SIB 12 12 20

RECALL 20V-761: CHECK 48 V CABLE CONNECTIONS TO THE STARTER GENERATOR (SGR)

This Service Information Bulletin (Revision 1) replaces SI B12 12 20 **dated December 2020**.

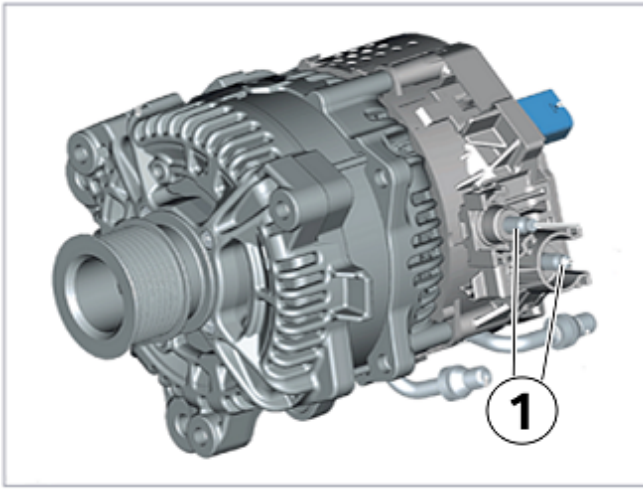
The 48-Volt battery cable connections to the starter / generator (SGR) may not have been assembled to specifications. Over time, this could lead to increased resistance at the connection(s) and, in rare cases, a thermal event.

Check B+/ B- connections cable for play (1).

If there is play in the connection to the SGR –

- Deactivate the 48 V electrical system (Repair instruction REP-TAT-P-6124-18-B47_48V)
- Remove and discard the flange nut on the B+ or B- cable.
- Install a new flange nut so that it’s carefully started by hand to avoid cross-threading
- Torque to 19 Nm
